Lowden Manor House, Chippenham

Heritage Statement Addendum

Submission Document – Listed Building Application

July 2026

5 Second Floor Plan as Proposed

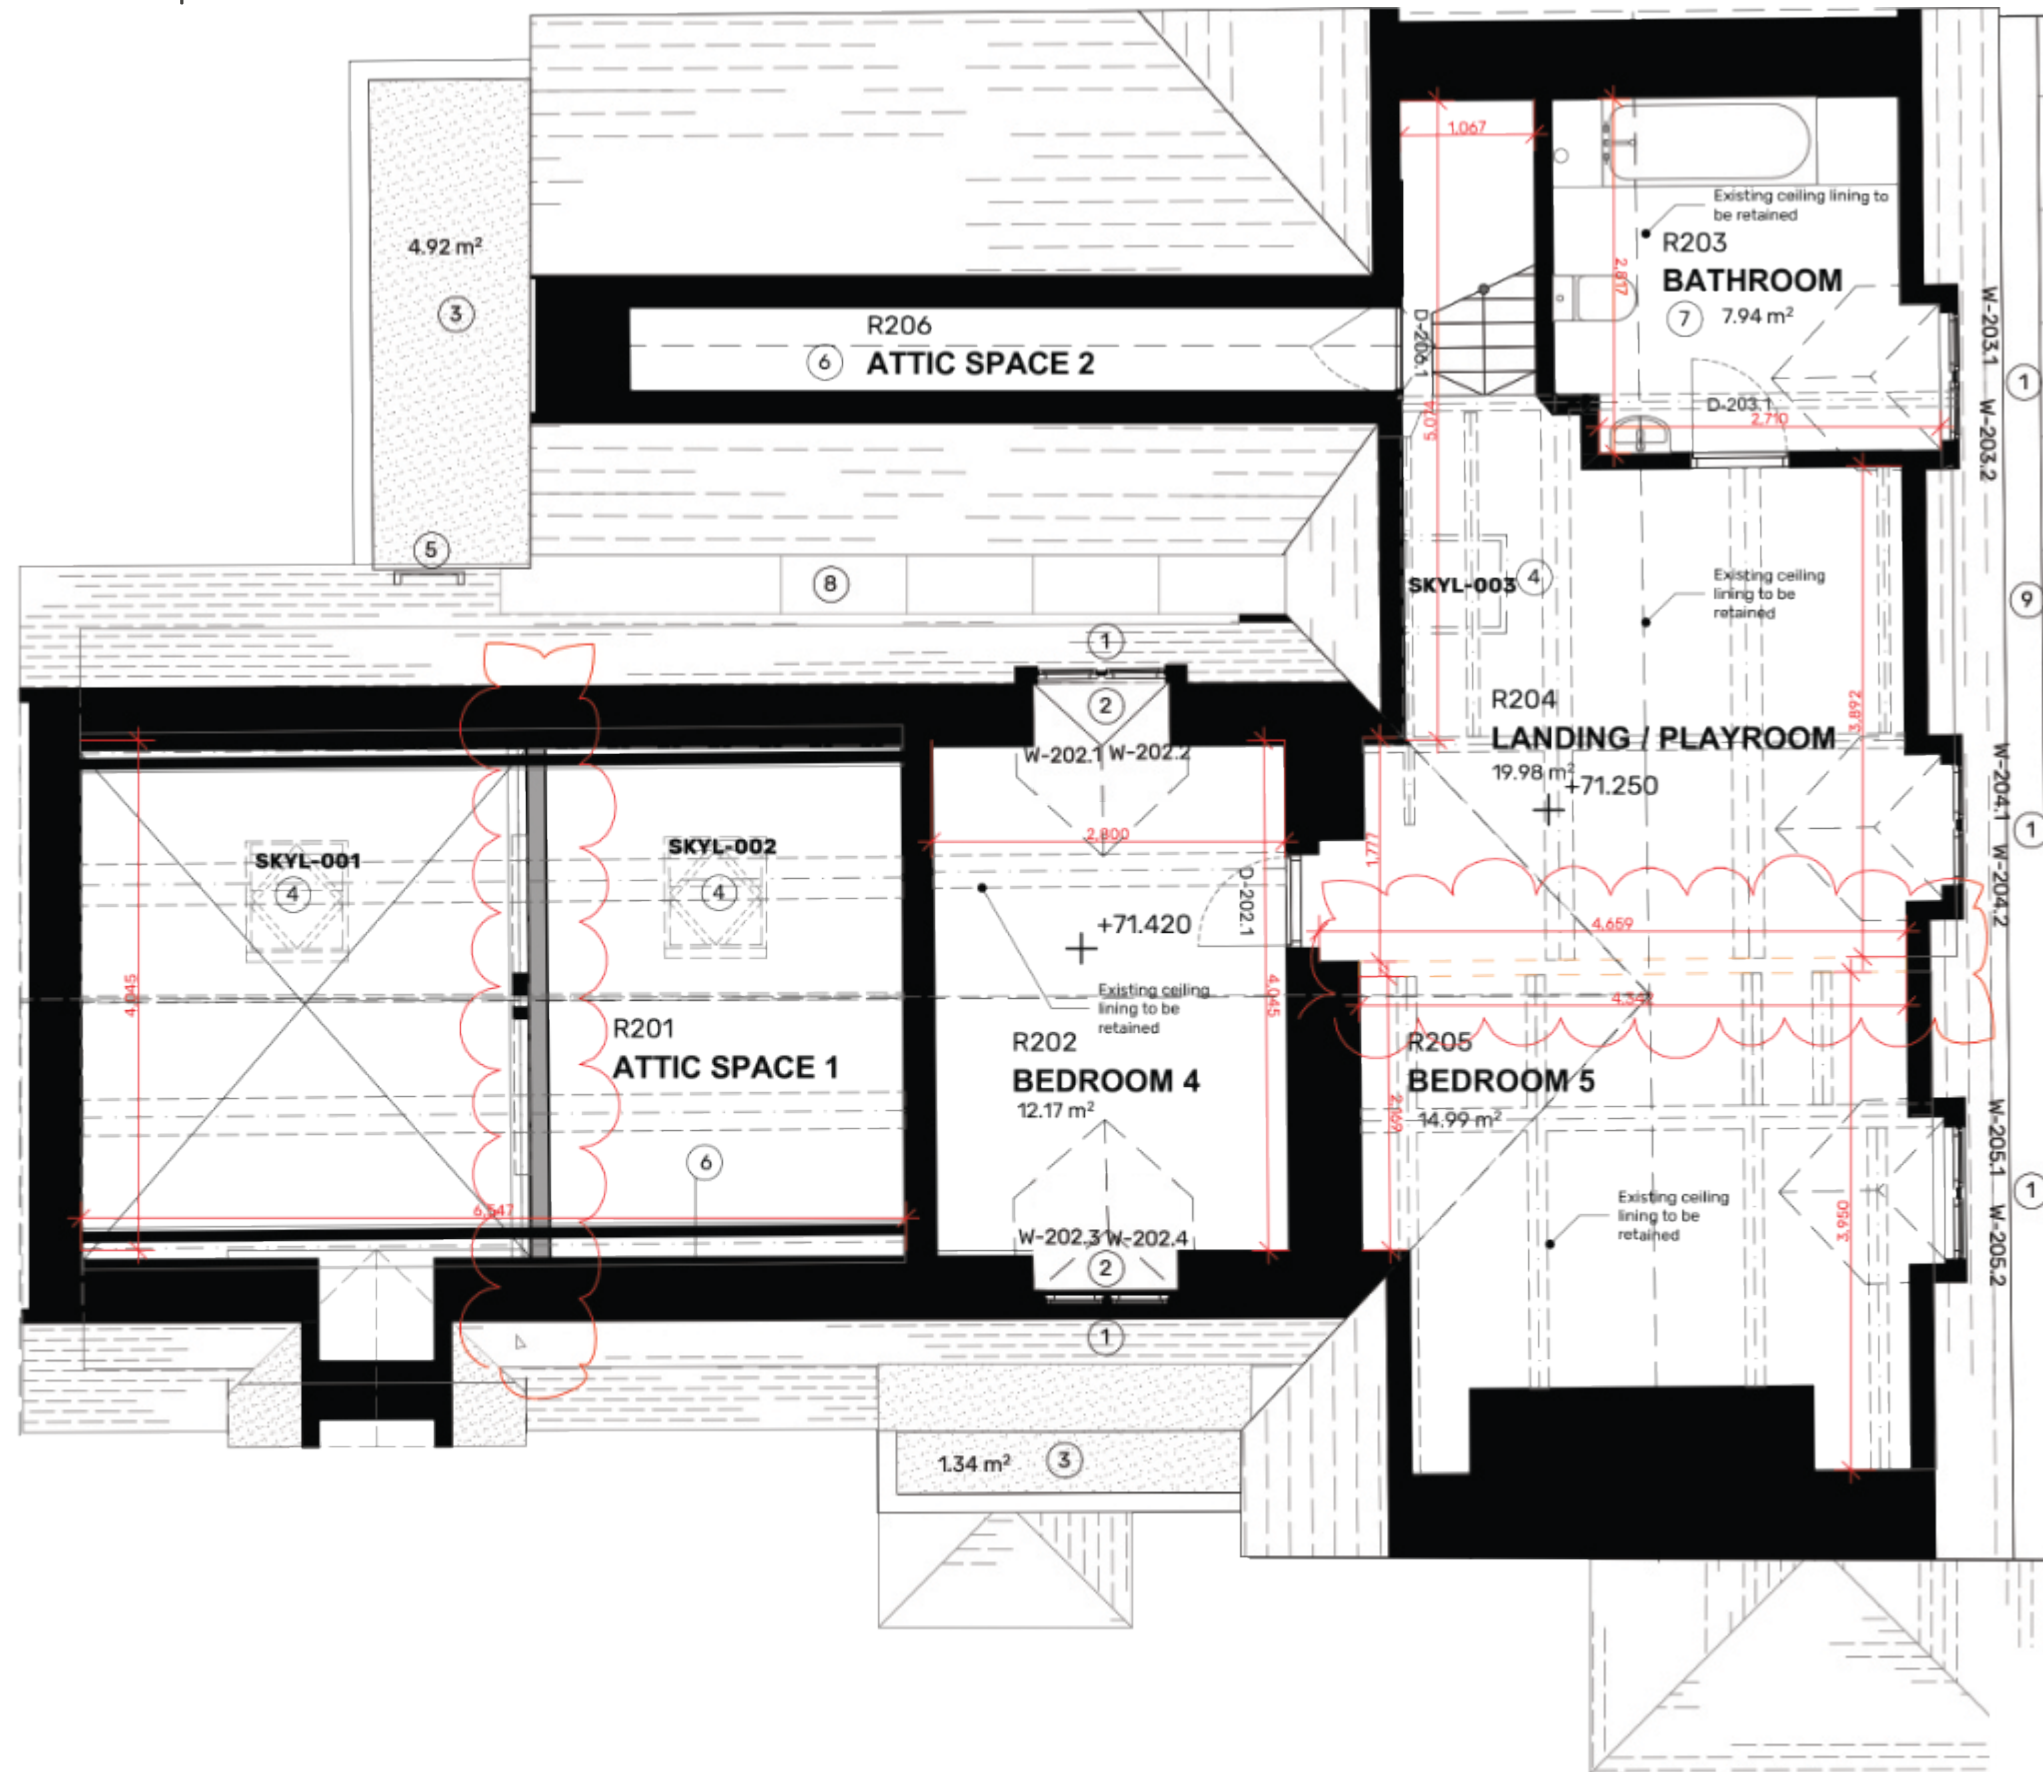
- ④ **New velux rooflights:**
 - 3 No. Velux windows (780 X 1400mm (MK08)) to be installed in roof.
- ⑤ **Access ladder:** New metal rung ladder to be installed to west elevation of chimney stack to allow maintenance access to/from roof valley.

6 Roof Plan as Proposed

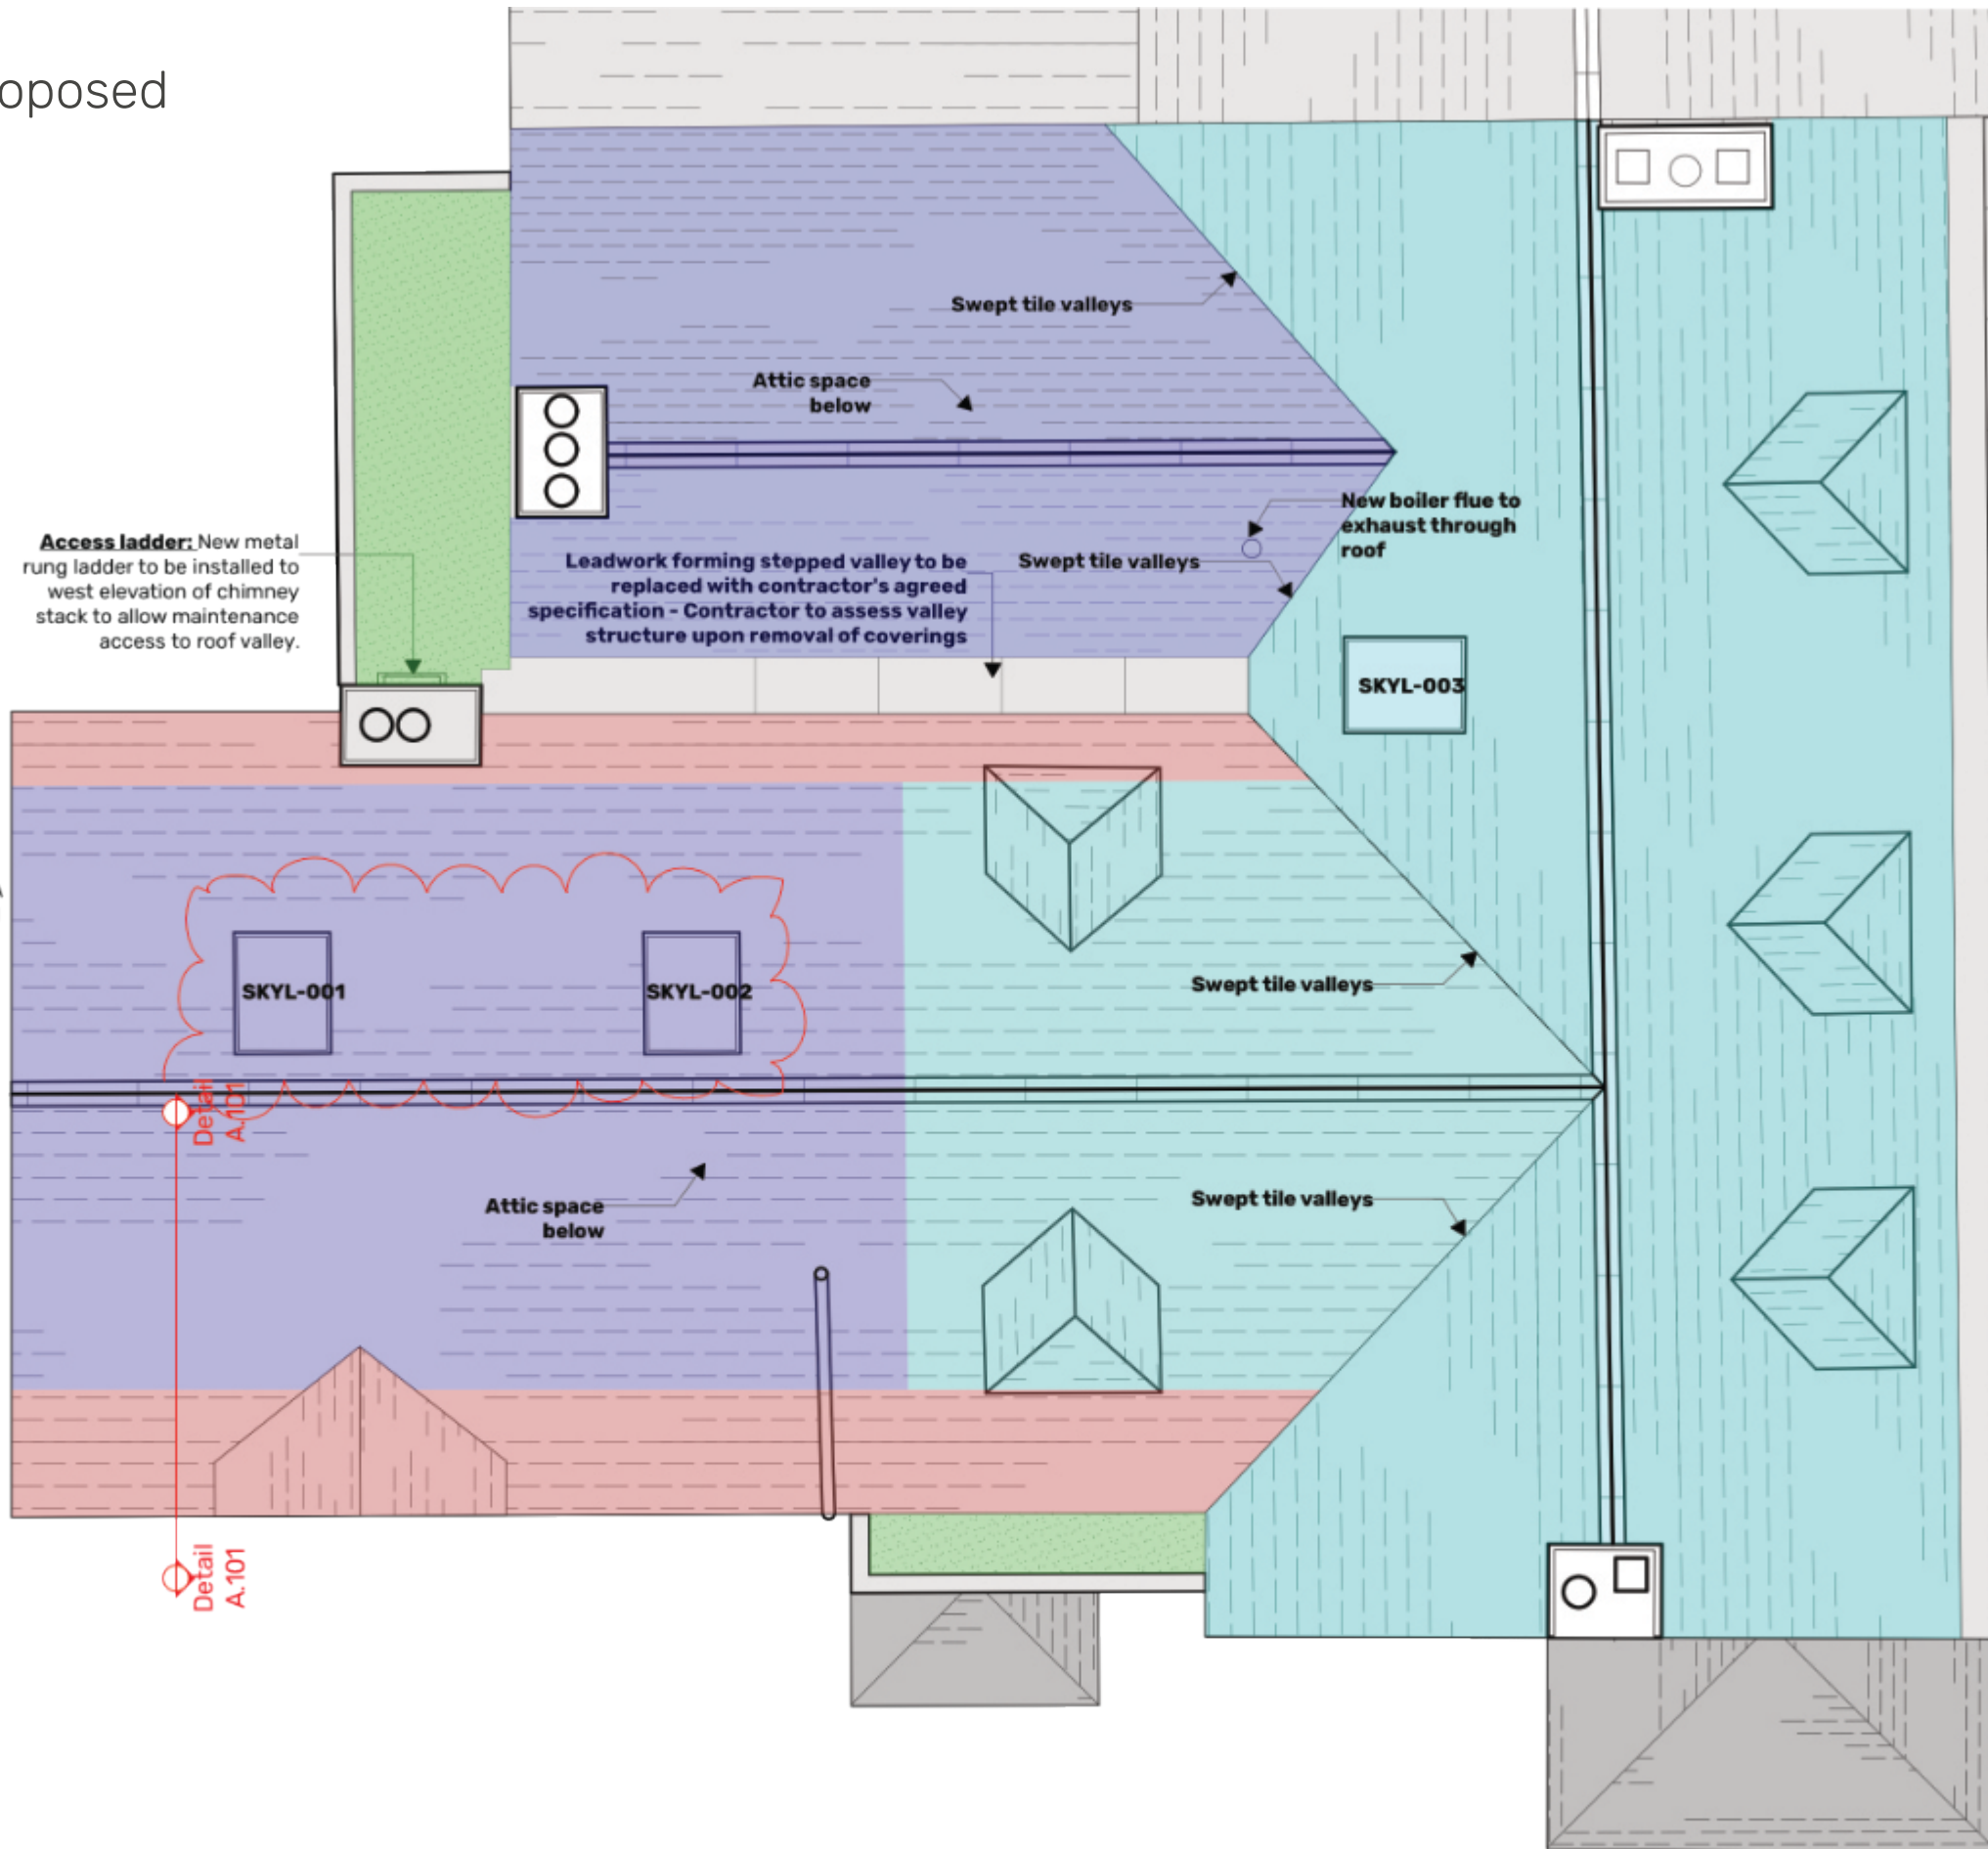
- Install Velux roof-lights between the upper purlin and ridge beam. Previous permission allowed for the installation between the two purlins. The new proposal moves them further up the roof but otherwise does not change their position.

Skylights: 3 No. Velux windows (780 X 1400mm (MK08)) to be installed in roof.
